Garden of Contemplation

at Didsbury Cenotaph

4/10/2023 revisions

v 4/10/2023
Surfaces plan

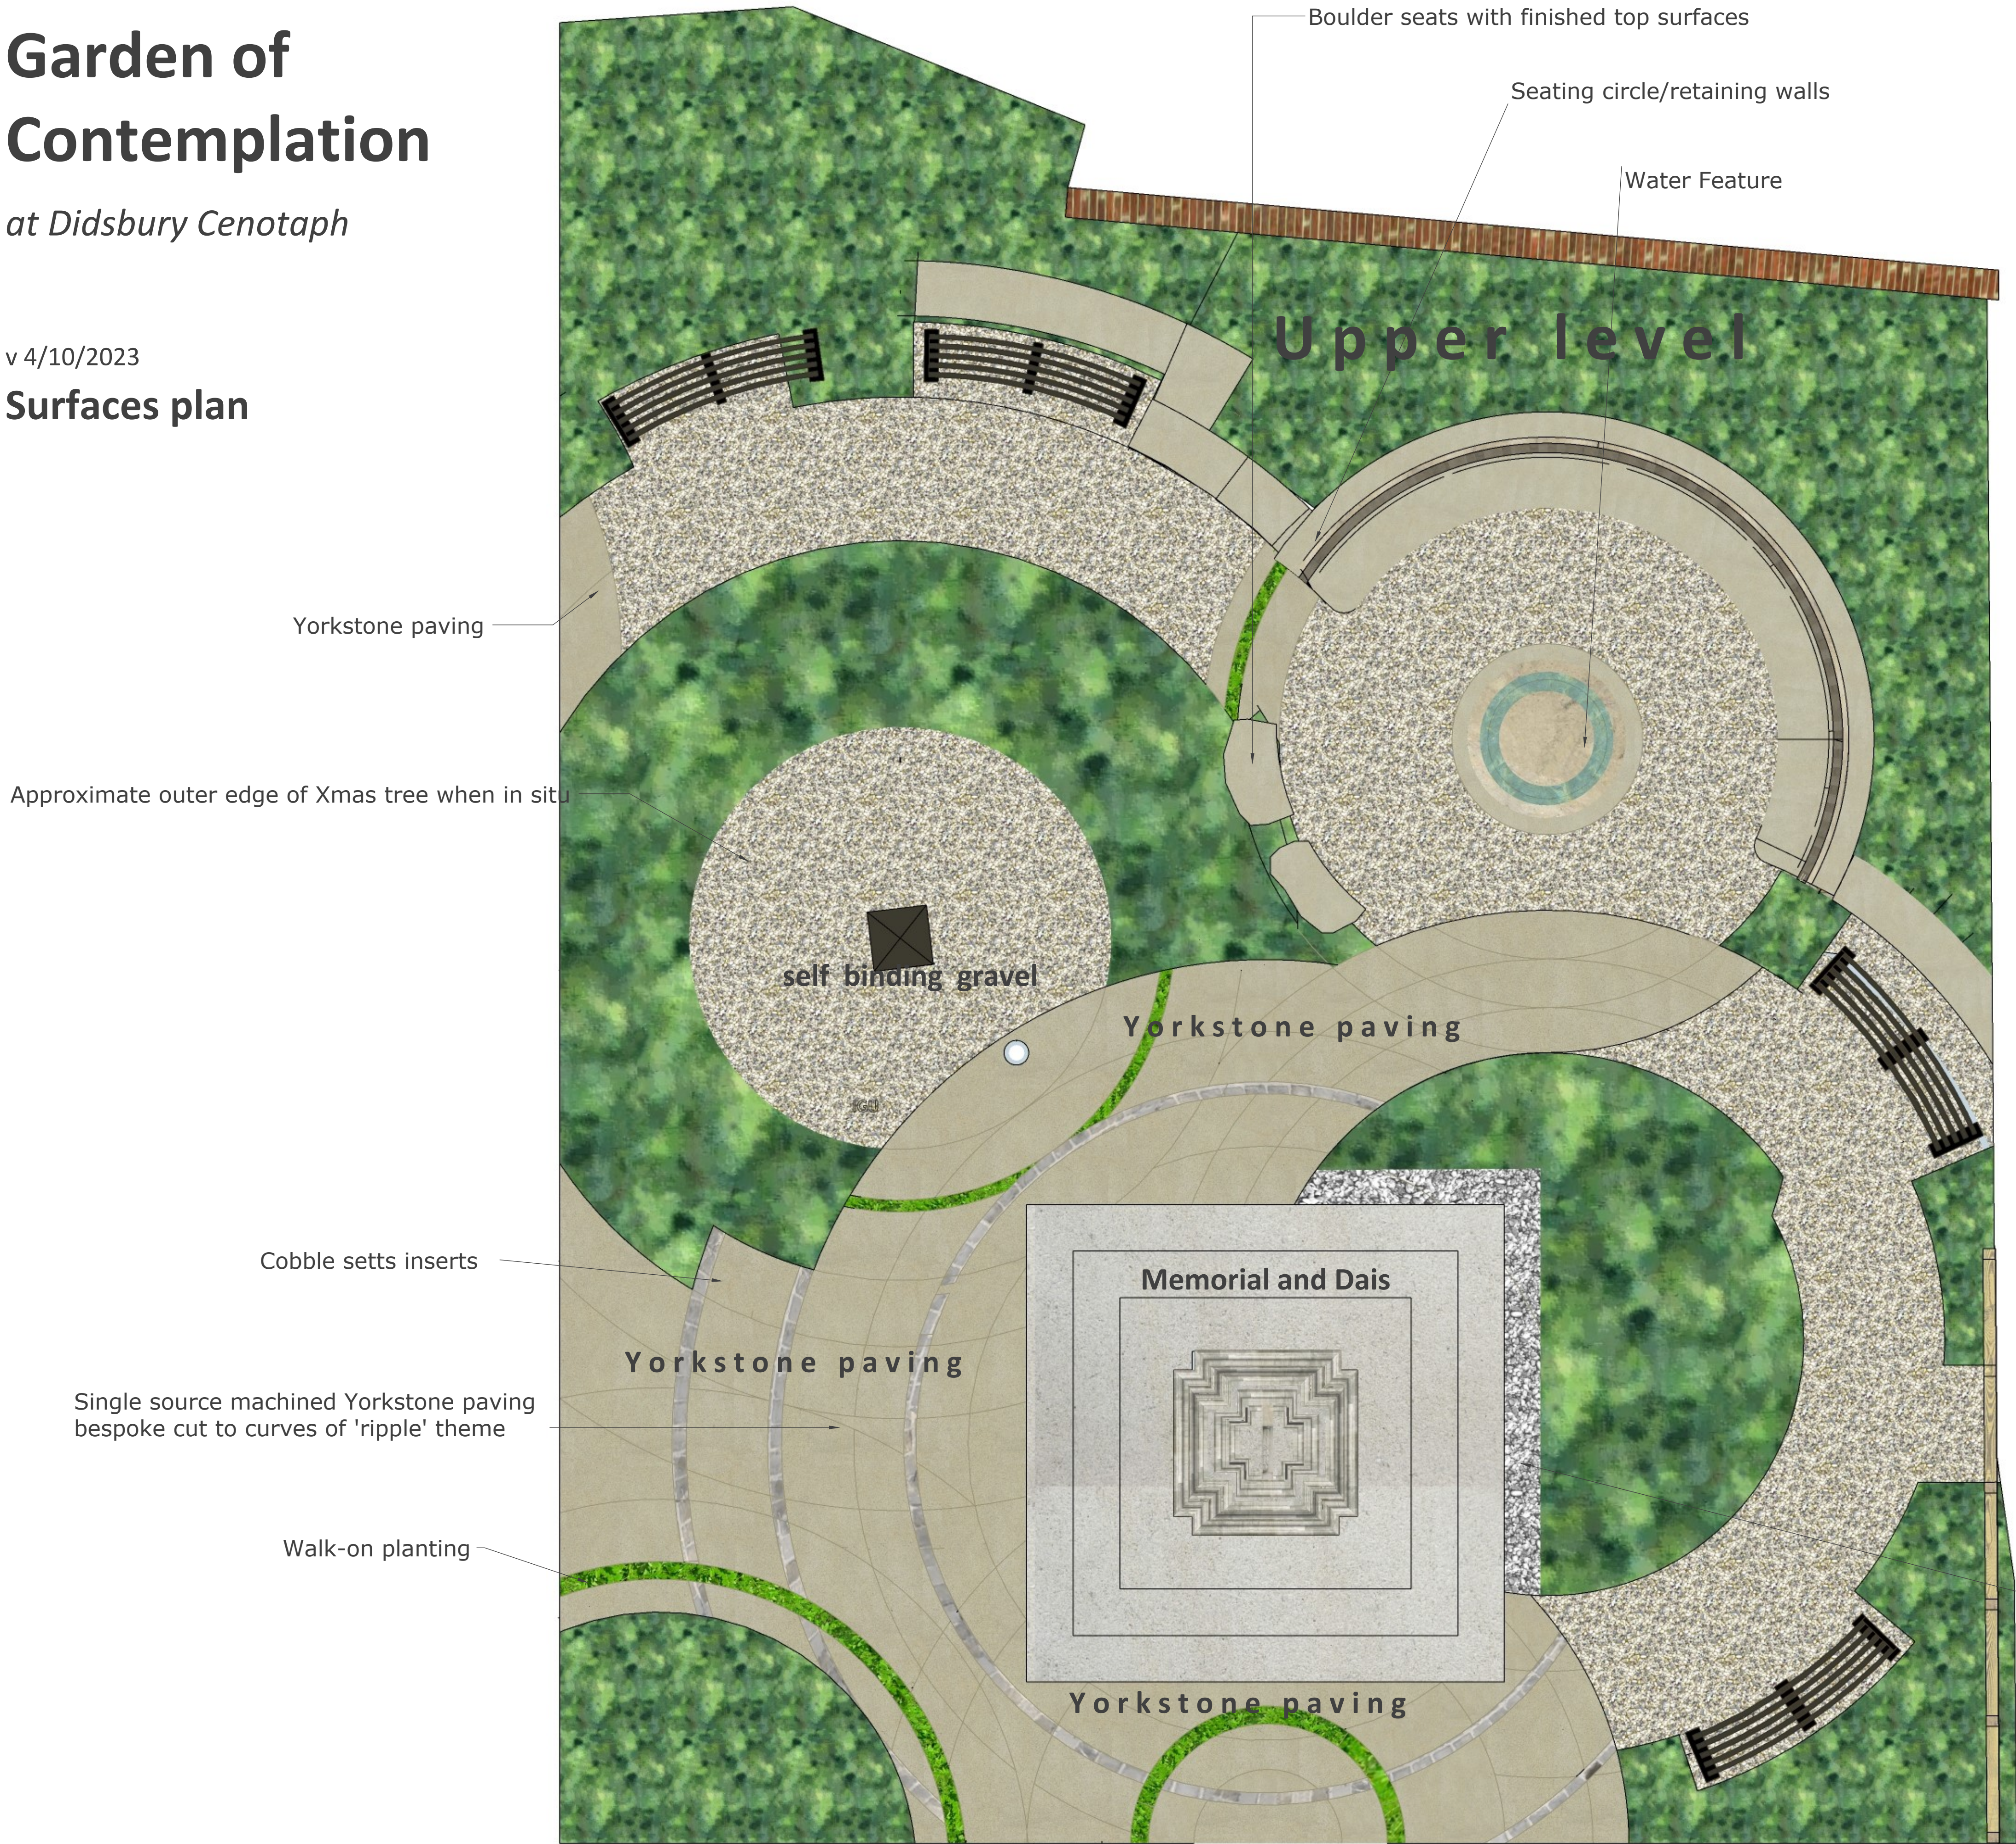
- Planting at back ie. NW of monument to be separated from dais by 40cm of drainage gravel functioning also as splash protection for the dais. Additionally planting closest to the dais to be low, and to offer further, evergreen, splash protection.

- Path around the planting to the North of the monument has been upgraded to the same 1.2metre minimum as elsewhere, and has been moved slightly further from the monument to allow for the drainage gravel area. Other areas have been adjusted in size and position to allow for this.

- The use of the single width pergola for climbers allows the North East perimeter bed to be narrowed to accommodate the moved and widened path
- Paved areas adjacent to the monument have been simplified. Pointing of the Yorkstone will be in a blending colour eg Flowpoint ECO Natural grey

- Cobbled sett circles have been simplified and reduced to a single course of 10cm/4 inch setts each. Reclaimed basalt to be used if available otherwise tumbled grey granite.
